BOARD OF COMMISSIONERS OF THE PORT OF NEW ORLEANS
NOTE TO PERSPECTIVE BIDDERS
CONTRACT FOR
FRANCE ROAD TERMINAL AND JOURDAN ROAD
REPAIRS TO PUMP STATIONS P2-P5 AND
PATTERSON PUMP STATION
DAMAGE BY HURRICANES KATRINA AND GUSTAV

August 1, 2011

ADDENDUM NO. 3

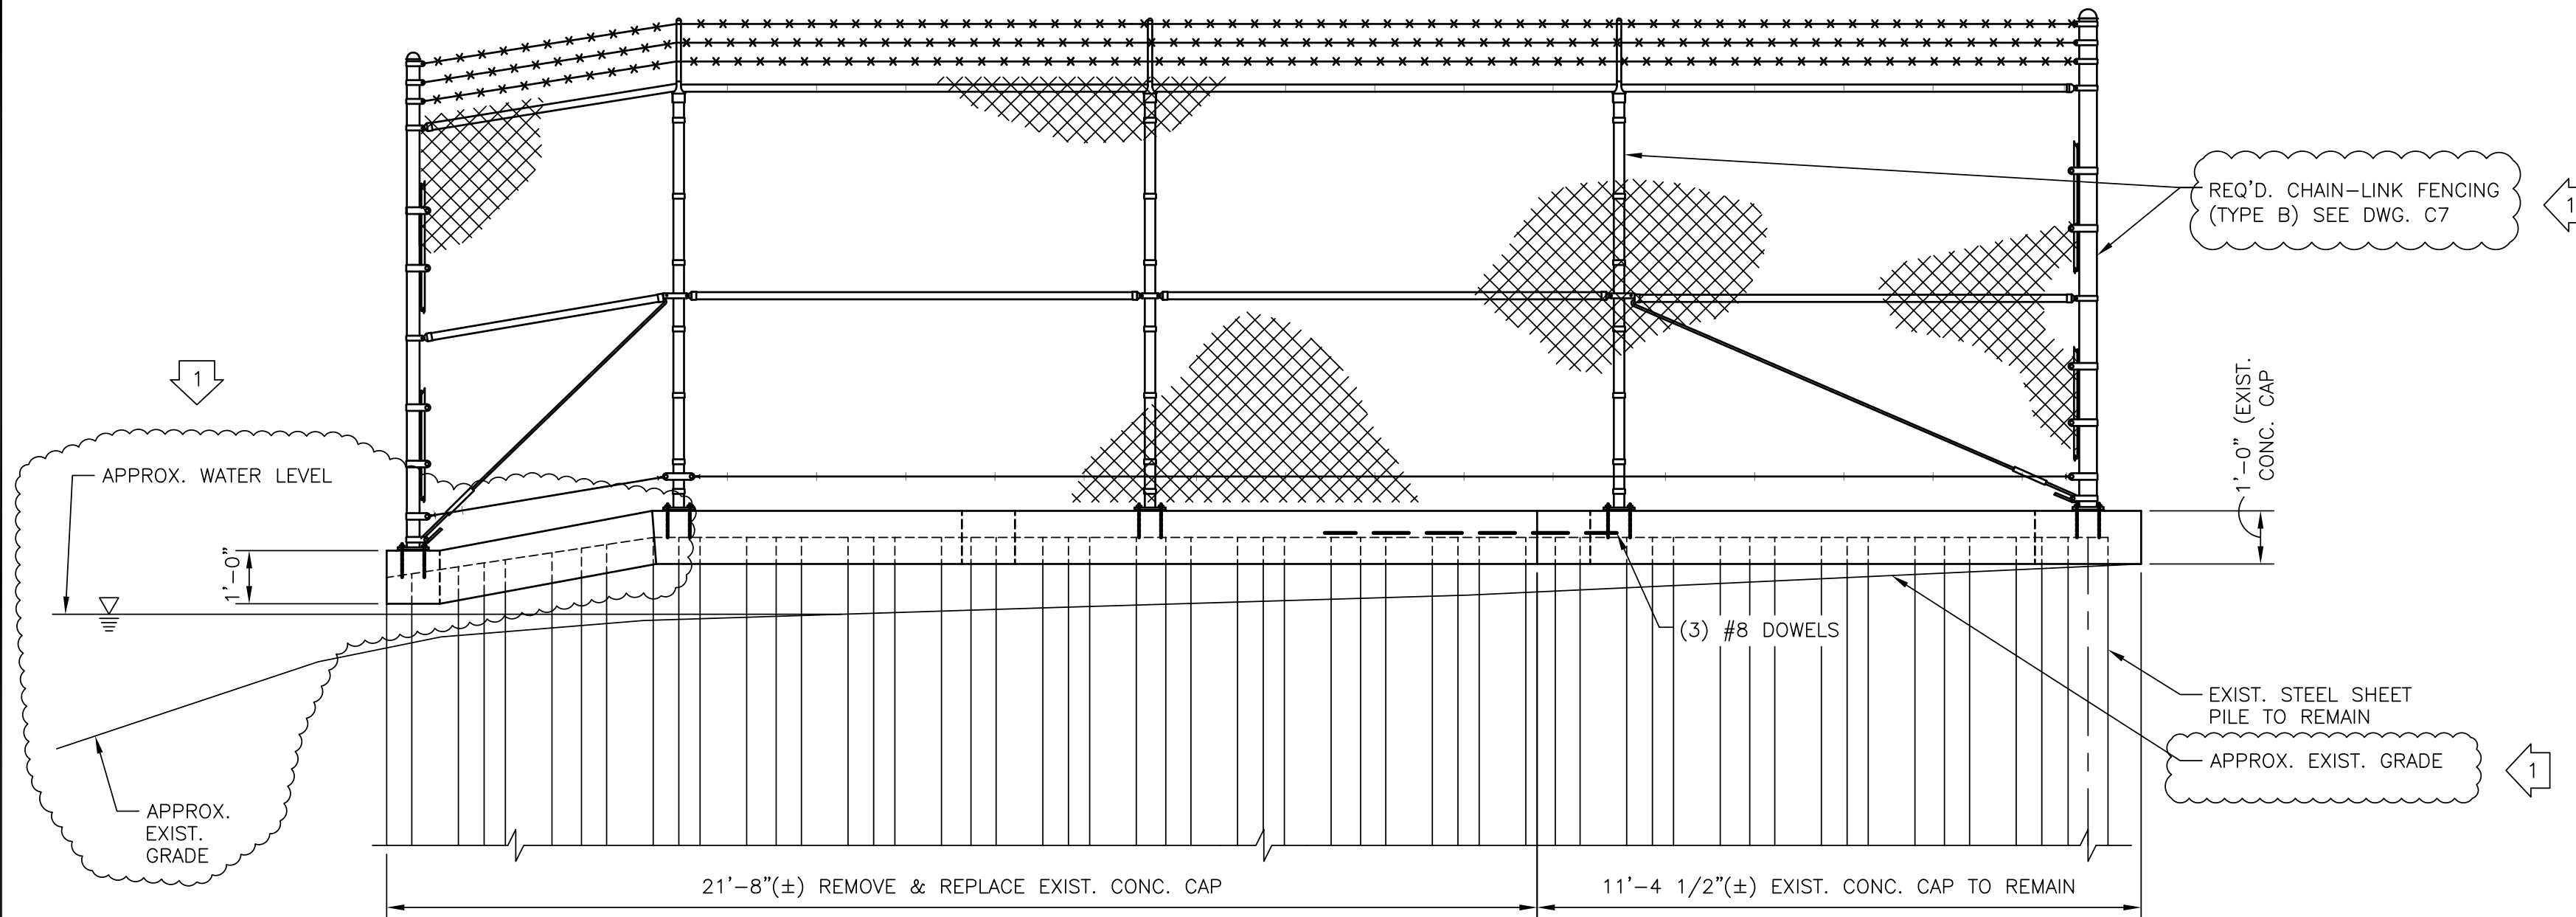
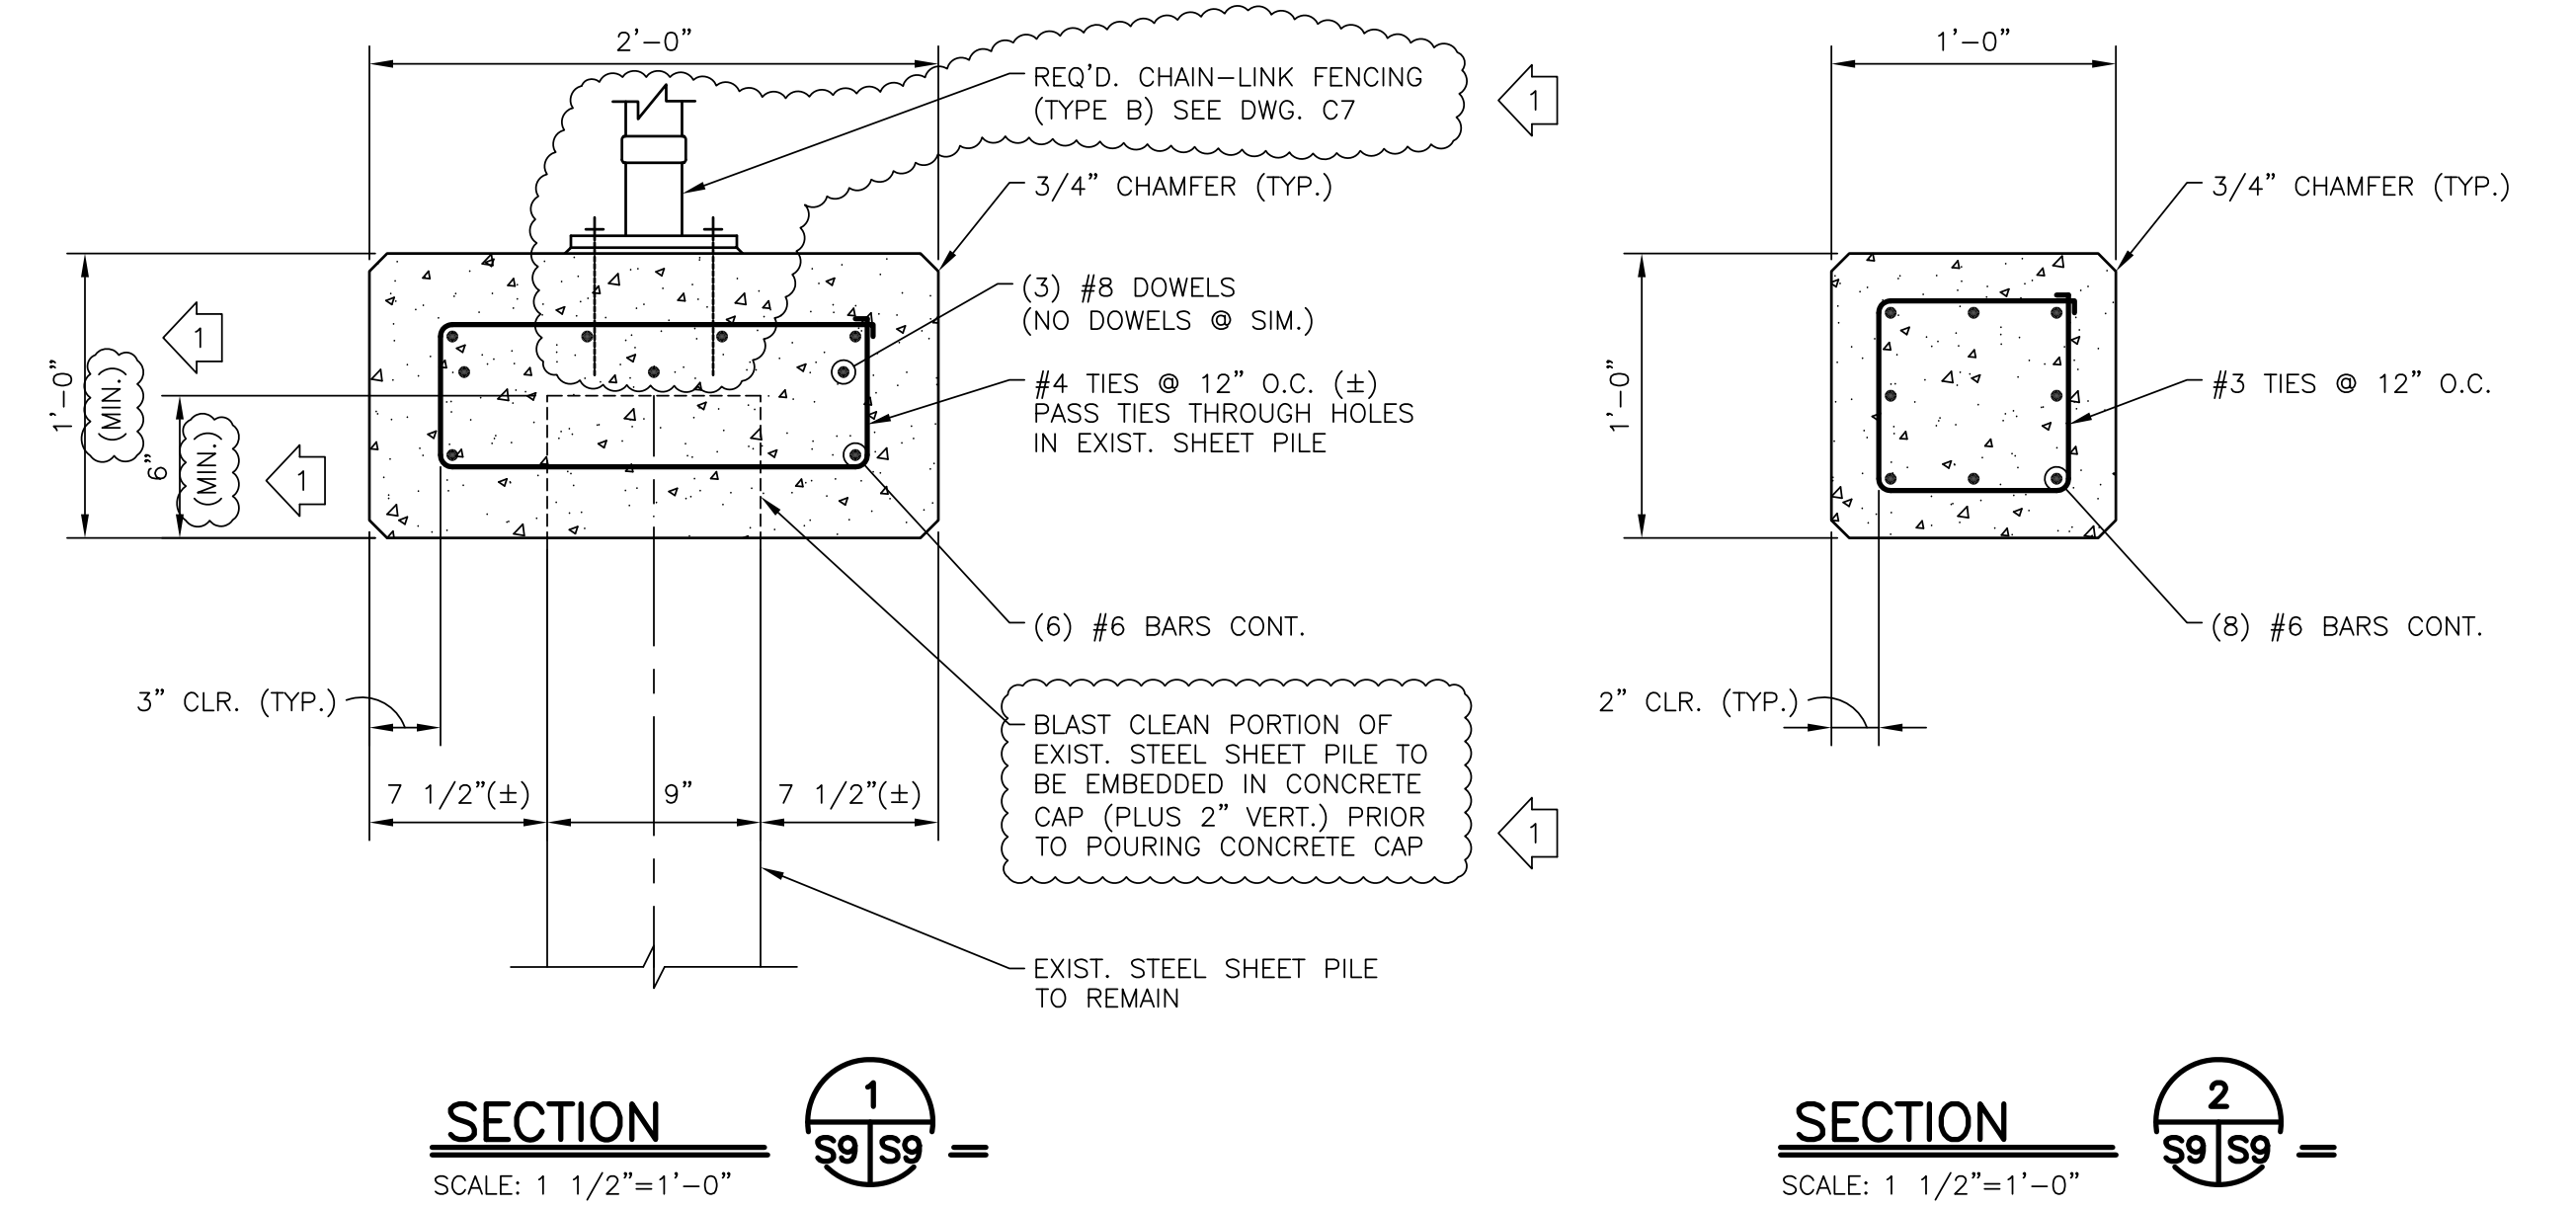
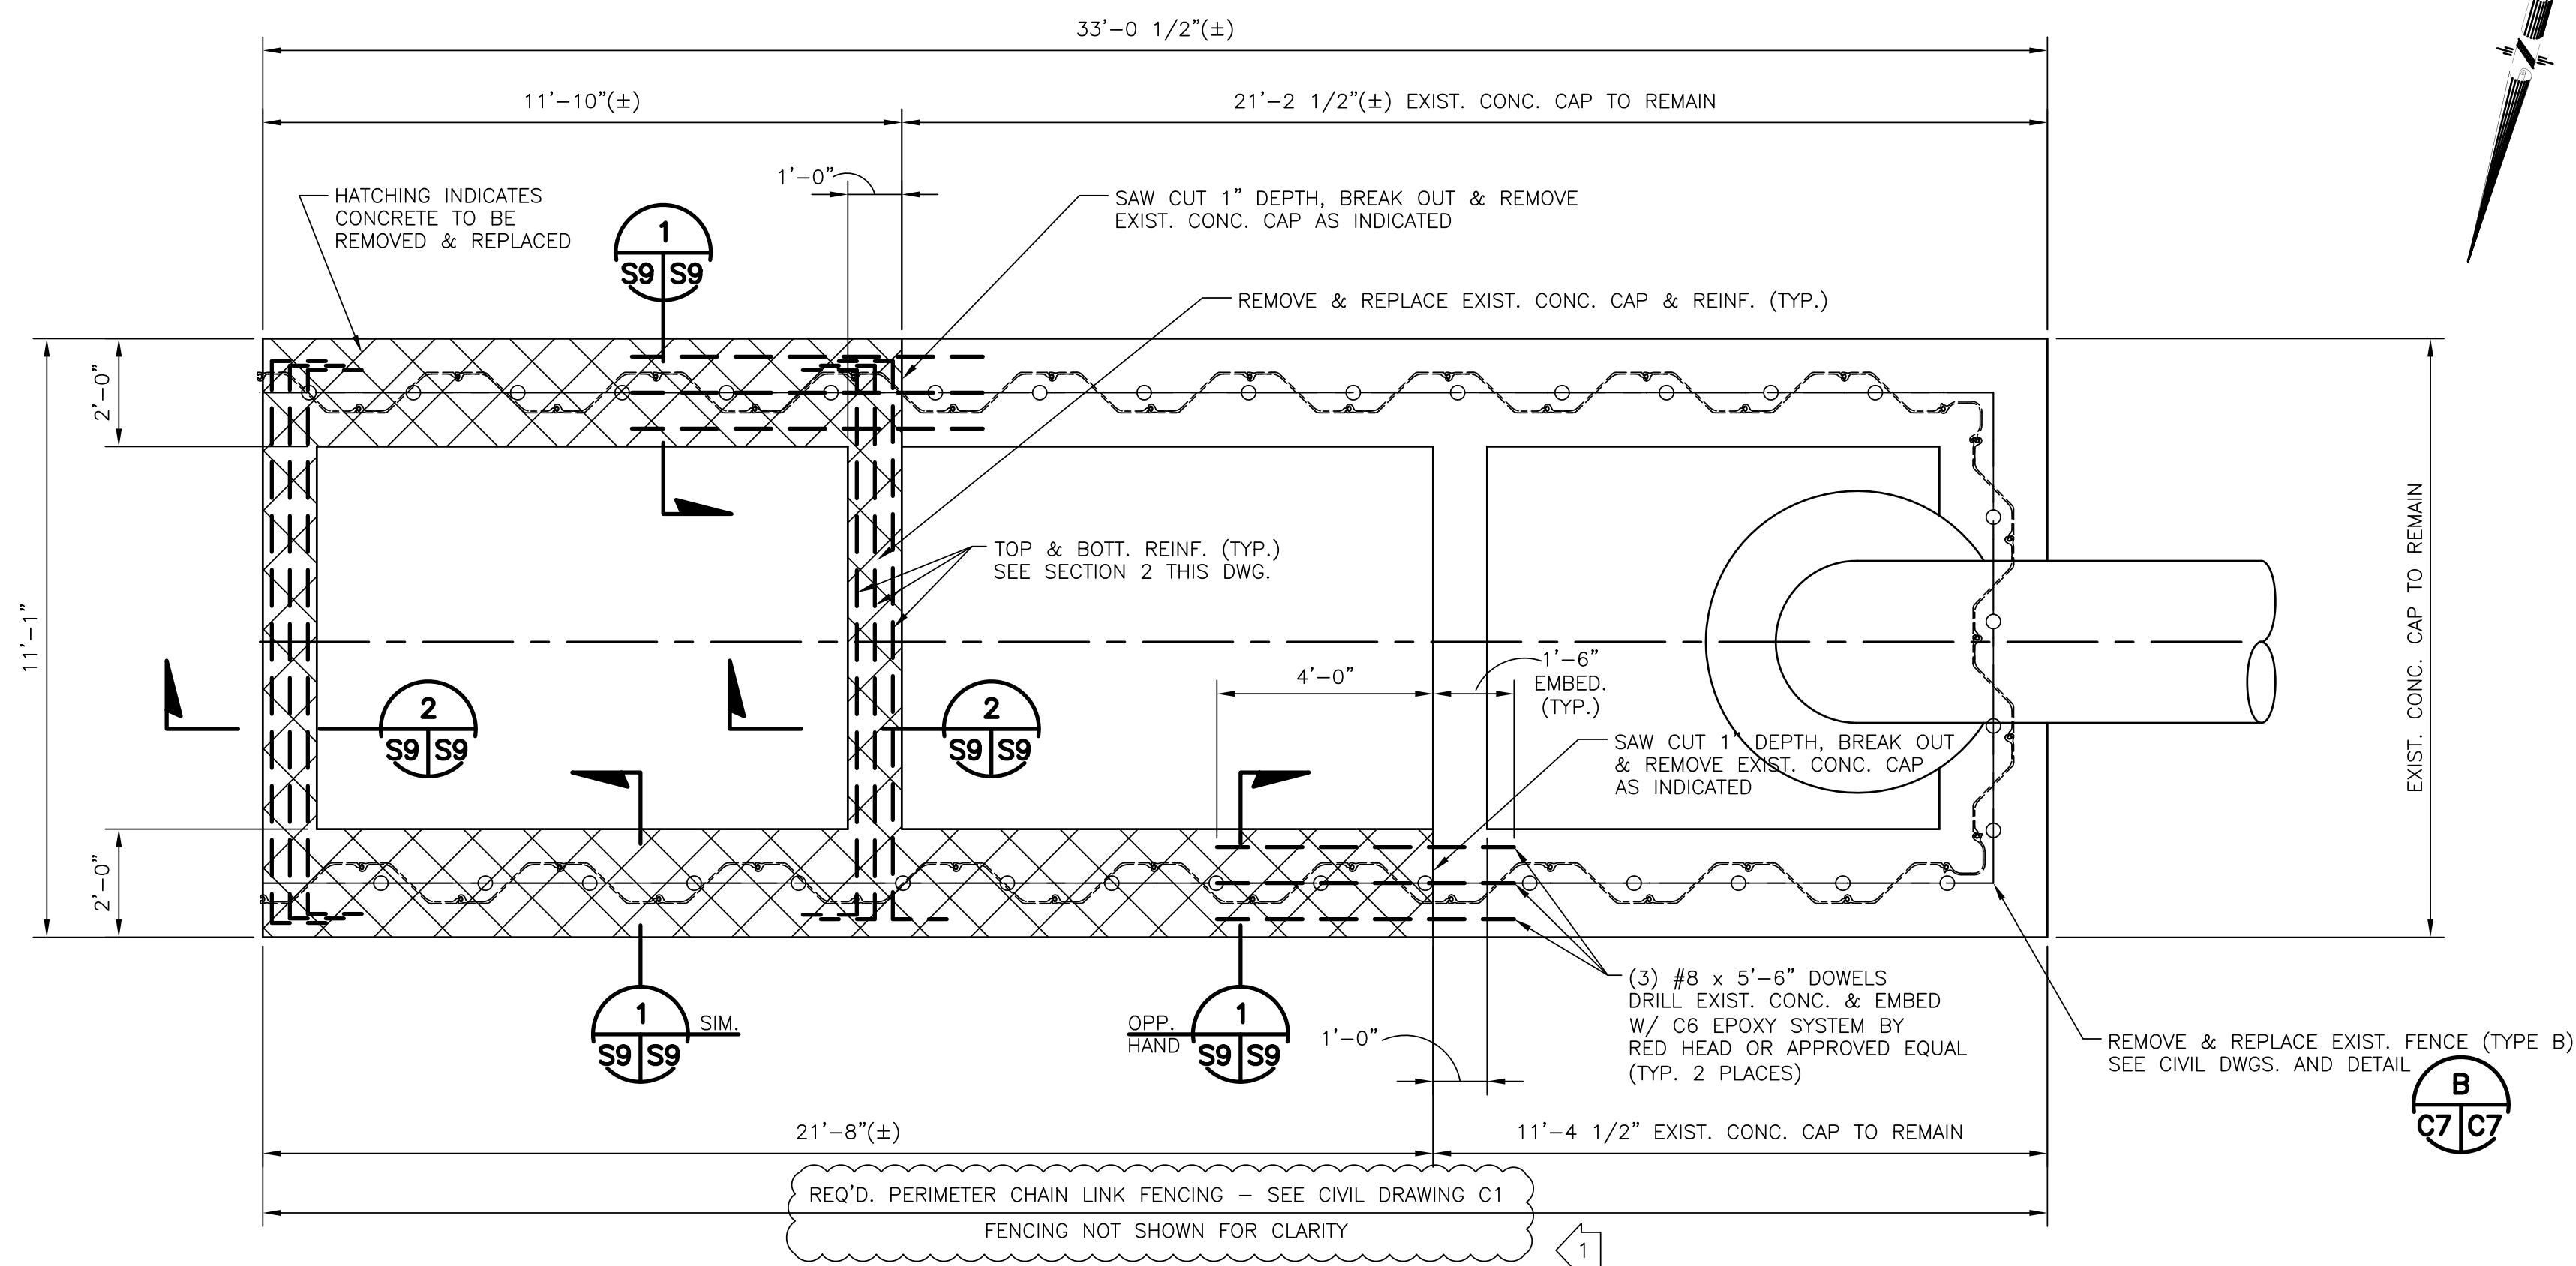
Q1: We weren't able to scale over the floodwall at Station P2, but were able to get a look at the discharge basin from the adjacent dock. It appears that the steel sheet piling at the end of that discharge basin may be damaged from what we can see in the photos we took. Does your office have any close-up photos of the end of this discharge basin that we can see? If the sheets are damaged, will they need to be replaced? If so, provide specs for new sheets, etc.

Q12: Pump Station No. 2 Outfall Structure exhibits damage on one side to the existing sheet pile. The sheet pile farthest from the floodwall appears to be tapered (or stepped) to a lower elevation than that shown on the project plans which would require forming and shoring beneath the existing water level. Please address this apparent discrepancy.

REV. 7	BY	DATE	REV. 6	BY	DATE	REV. 5	BY	DATE	REV. 4	BY	DATE	REV. 3	BY	DATE	REV. 2	BY	DATE	REV. 1	BY	DATE	ADDENDUM NO. 3 REVISED END OF EXISTING SHEET PILE & ADDED NOTES TO DETAILS 08/01/2011
--------	----	------	--------	----	------	--------	----	------	--------	----	------	--------	----	------	--------	----	------	--------	----	------	--

Answer: The contract documents do not require the Contractor to remove and replace any of the existing sheet pile. When the damaged concrete cap and debris are removed, the Contractor shall contact the Engineer to visually assess the condition of the discharge basin prior to construction of the new concrete cap. As requested, photographs of the discharge basin are shown on the next page.

Answer: The end is tapered. See Item 22 below.
